Application Bulletin AB-10

Substituting the RC5051 for the RC5050

Figure 1. RC5050 and RC5051 Application Differences

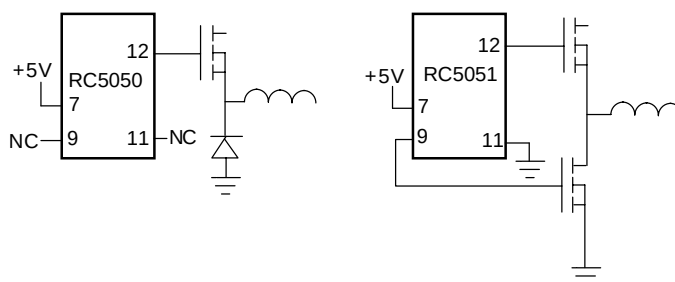
The RC5050 and the RC5051 are both programmable DC-DC controllers for low voltage microprocessors. Their only functional difference in an application is that the RC5051 is designed to run a synchronous rectifier in place of the RC5050's freewheeling diode (see Figure 1).

In the RC5050, pin 9 is not connected, whereas in the RC5051 it drives the gate of the synchronous MOSFET rectifier. In the RC5050, pin 11 is not connected, whereas in the RC5051 it is a power ground. Finally, in the RC5050, pin 7 powers the internal digital logic from +5V, whereas in the RC5051 it powers the synchronous MOSFET's gate driver.

The RC5051 can be substituted for the RC5050 in all applications, provided that pin 9 has no trace attached to it; and pin 11 either has no trace attached, or is attached to power (not signal) ground.

If neither pin 9 nor pin 11 has a trace going to it, the RC5051 may be substituted for the RC5050. If pin 9 has no trace going to it, and pin 11 is attached to power ground (NOT signal ground), the RC5051 may be substituted for the RC5050. Other than in these two cases, the the RC5051 should NOT be substituted for the RC5050.
